**ADDENDUM NUMBER ONE (1)  
TO THE PLANS AND SPECIFICATIONS FOR:**

**NORTH ECHS  
AND  
COLLEGE & UNIVERSITY CAMPUS  
STUDENT RESTROOM RENOVATIONS**

**PSJA ISD  
Bid # 18-19-042  
Project No. 19.04**

GIGNAC & ASSOCIATES  
3700 N. 10<sup>th</sup> STREET, SUITE 205  
McALLEN, TEXAS 78501  
(956) 686-0100

**BUILDING K  
 DEMO PLAN**

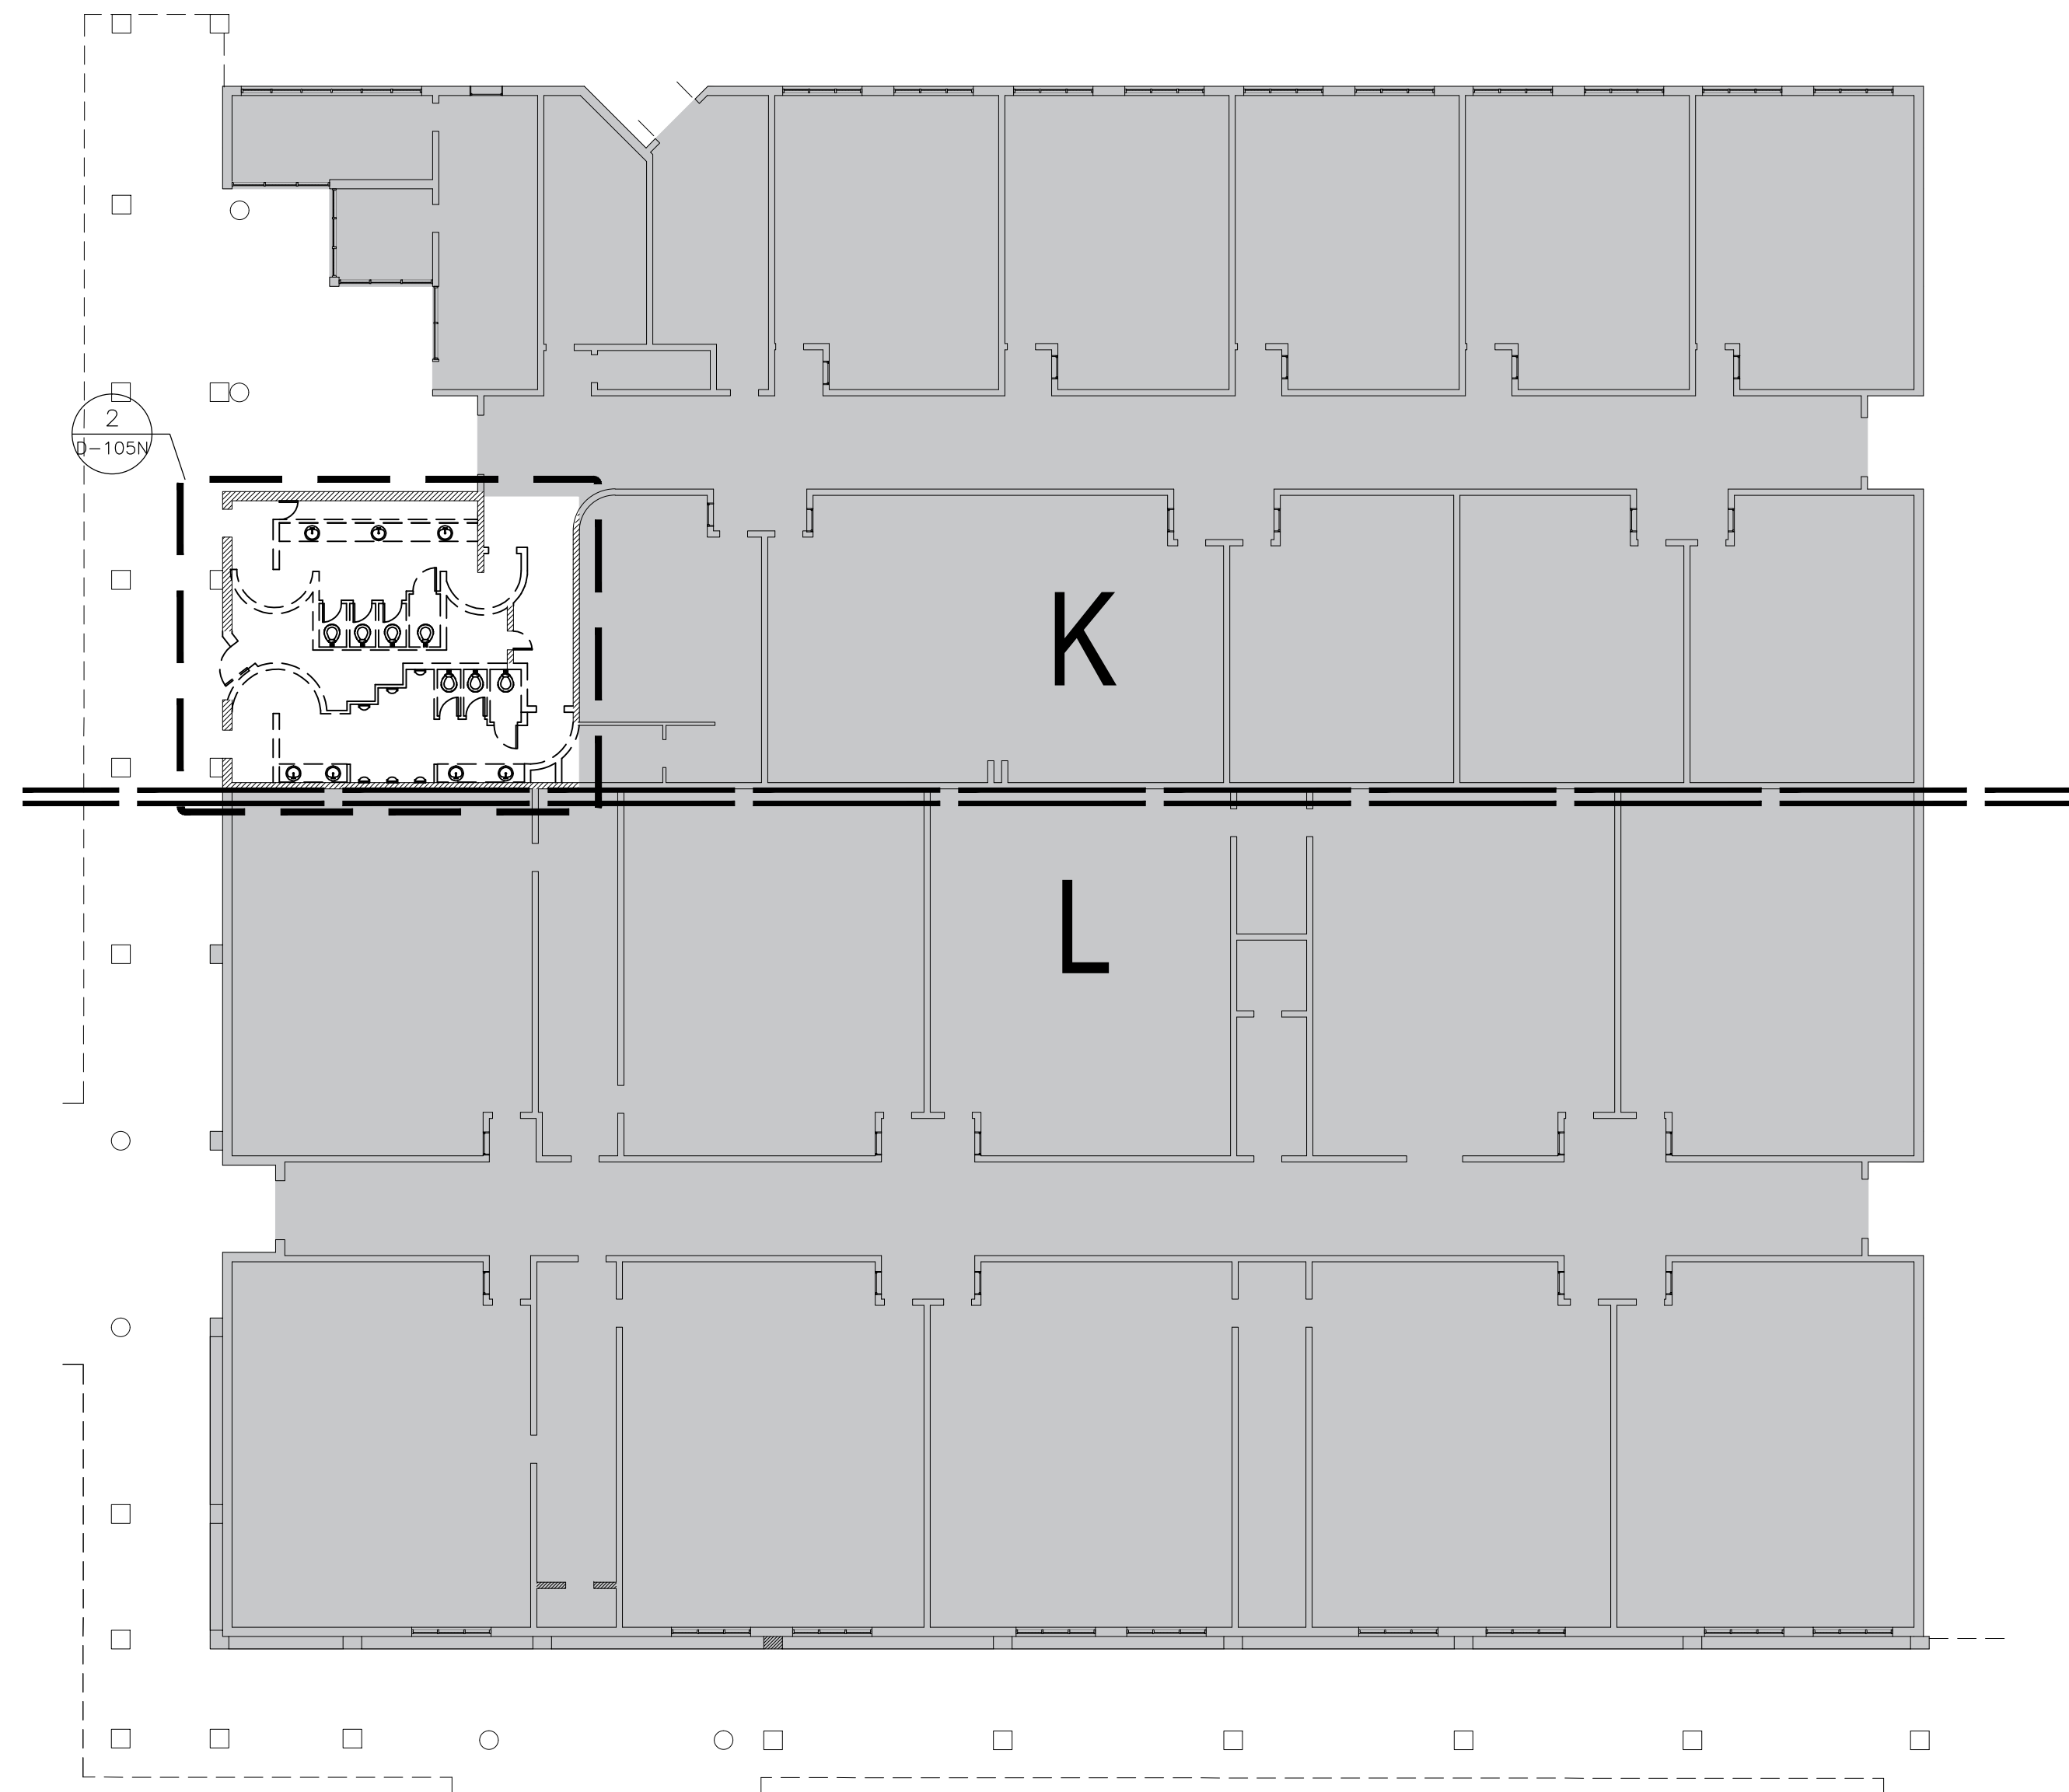
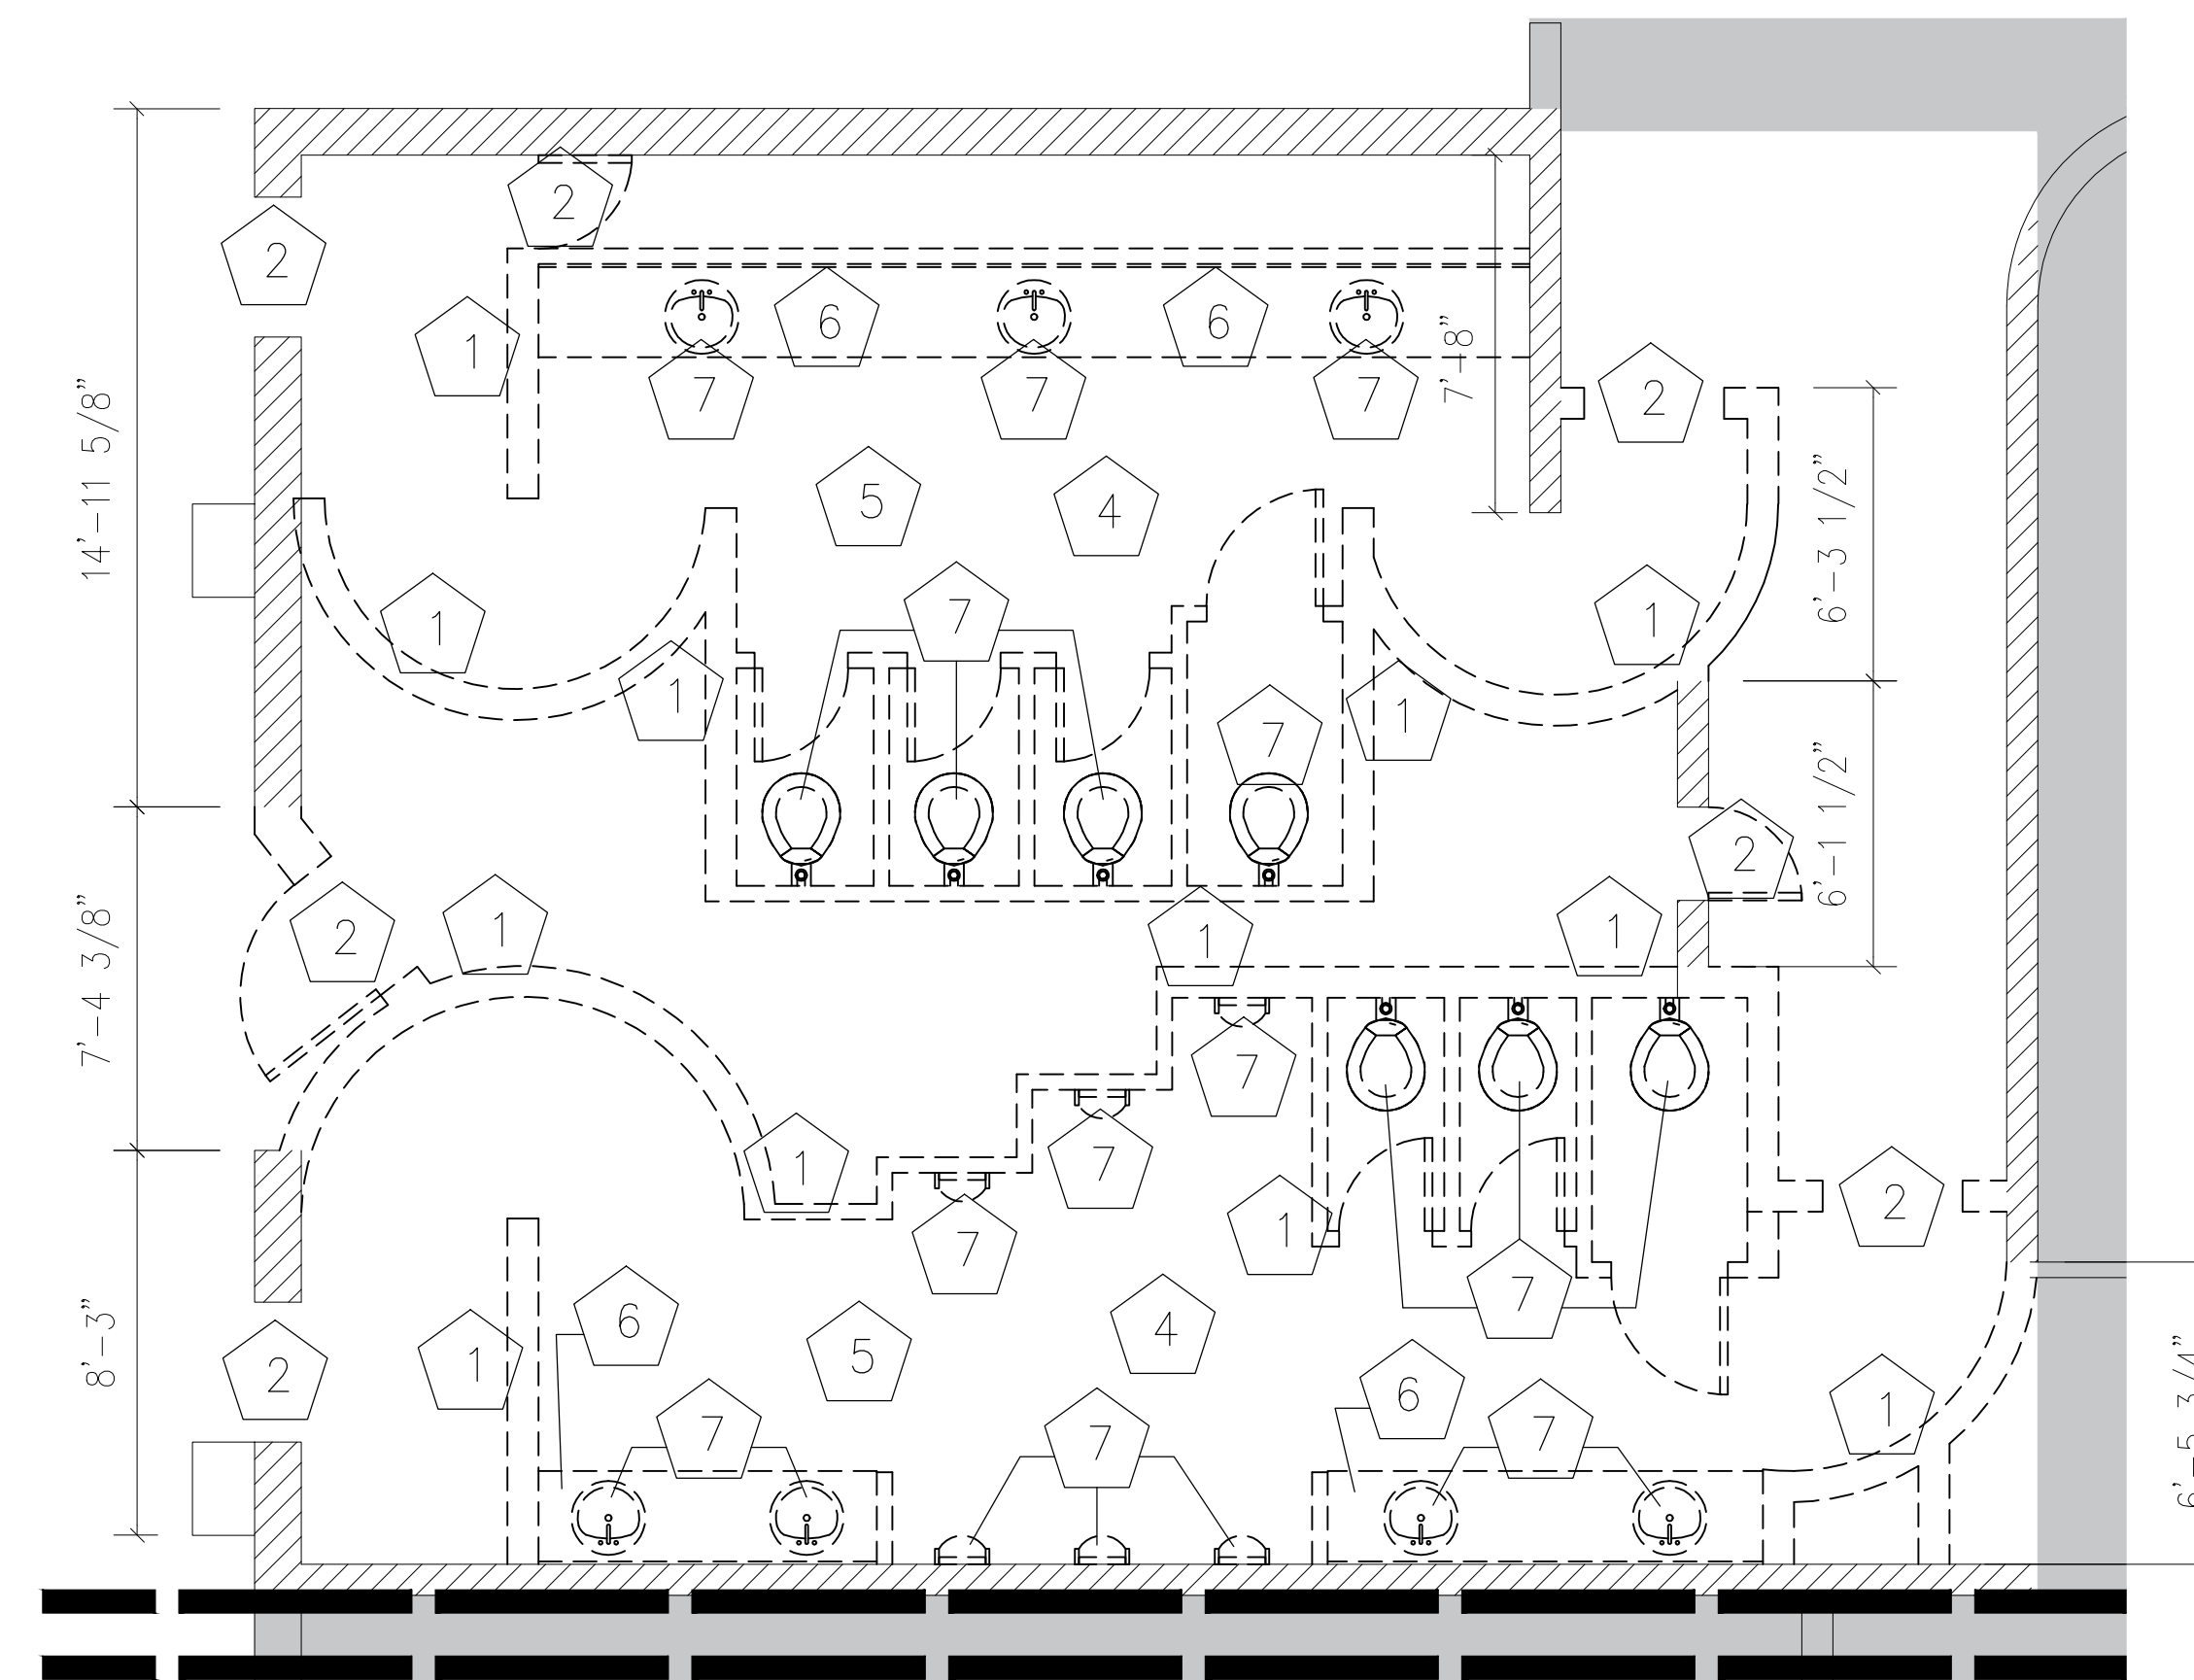
Sheets D-100N to D-106N included in this Addendum shall replace their respective sheets in the Contract Documents. The following sheets provide additional dimensions for further clarification.
